UNITED STATES PATENT AND TRADEMARK OFFICE

10/799,750

Office Action Summary

DETAILED ACTION

FIG. 1

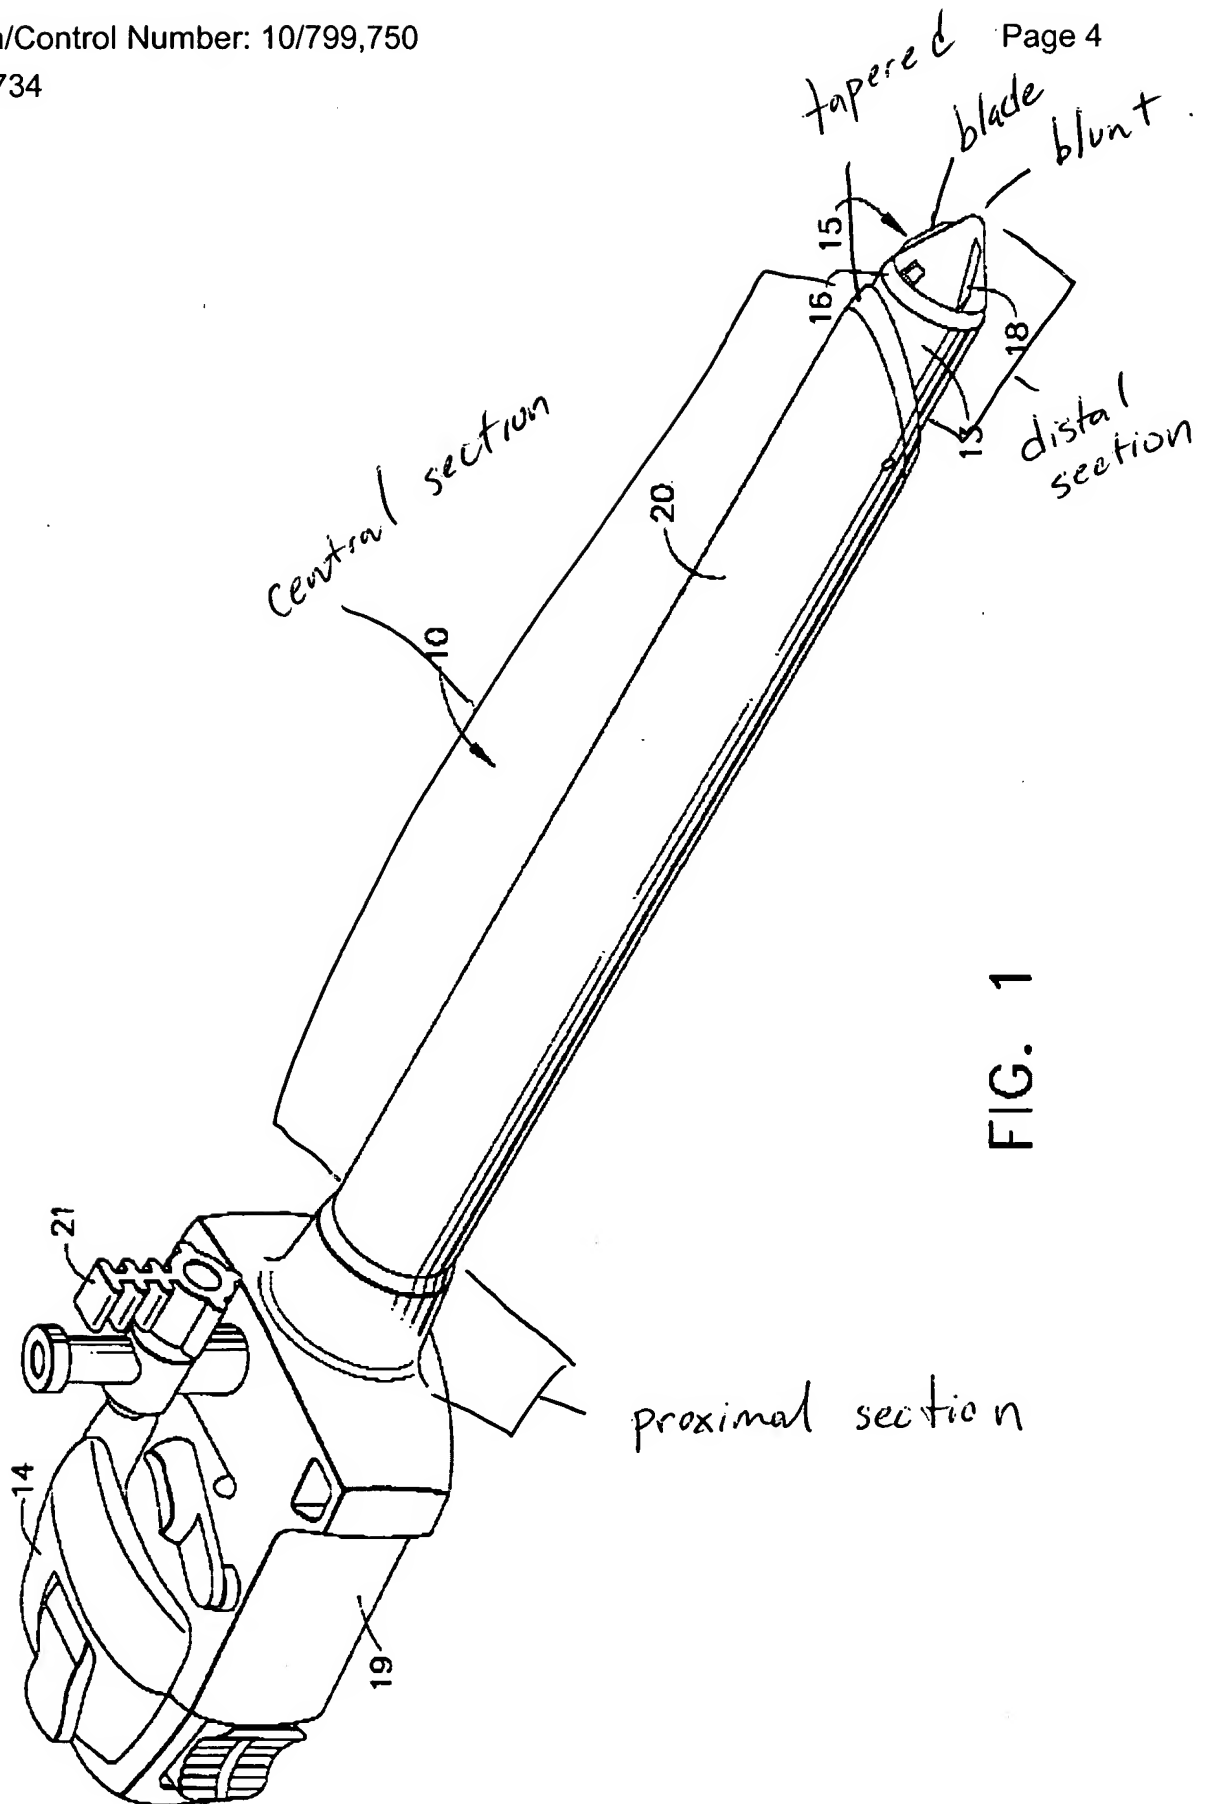
3. Claims 1-3, 5, 6, and 8-11 are rejected under 35 U.S.C. 102(b) as being anticipated by Goodwin et al. 5817061.

4. Goodwin teaches an obturator tip having a longitudinal axis, said tip comprising: an elongated distal section having a first diameter, said distal section having a blunt, rounded, distal end for separating tissue; an elongated proximal section having a second diameter, a central section for connecting said distal section and said proximal section; and a pair of blades located on opposing sides of said tip, said blades positioned about 180 degrees apart from each other; wherein said central section further comprises tapered outer surfaces for connecting said proximal section and said distal section; wherein a first end of at least one of said blades is attached to said distal section of said obturator tip; wherein said second diameter is greater than said first diameter; wherein said outer surfaces of said central section taper in a linear fashion; wherein said blades have an arc shaped configuration; wherein said blades have upper and lower surfaces, said upper surfaces sloping in a downward direction; wherein said first diameter of said distal section is uniform; and wherein said second diameter of said proximal section is uniform.

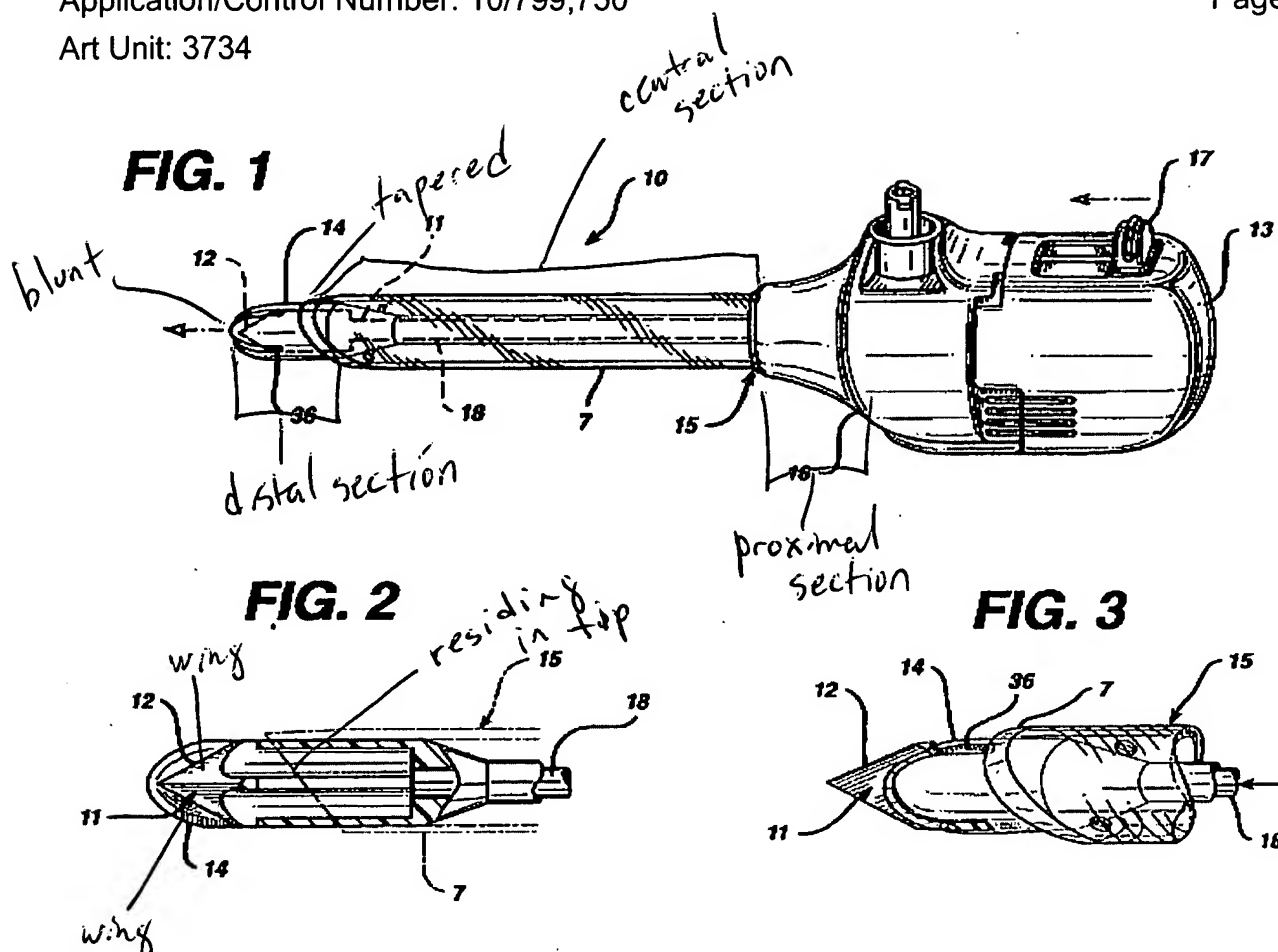
5. Claims 12-14 and 17-20 are rejected under 35 U.S.C. 102(b) as being anticipated by Stephens et al. 5522833.

6. Stephens et al. teaches an obturator tip having a longitudinal axis, said tip comprising:

an elongated distal section having a first diameter, said distal section having a blunt, rounded, distal end for separating tissue;

a proximal section having a second diameter;

a central section for connecting said distal section and said proximal section; and

an insert or molded blade residing partially within said tip, said blade having two wing elements located on opposing sides of said blade and protruding outwardly away from said longitudinal axis; wherein said central section further comprises tapered outer

surfaces for connecting said proximal section and said distal section; wherein said outer surfaces of said central section taper in a linear fashion; wherein said blades have

an arc shaped configuration; wherein said blades have upper and lower surfaces, said upper surfaces sloping in a downward direction; wherein said first diameter of said distal

section is uniform; and wherein said second diameter of said proximal section is

uniform.
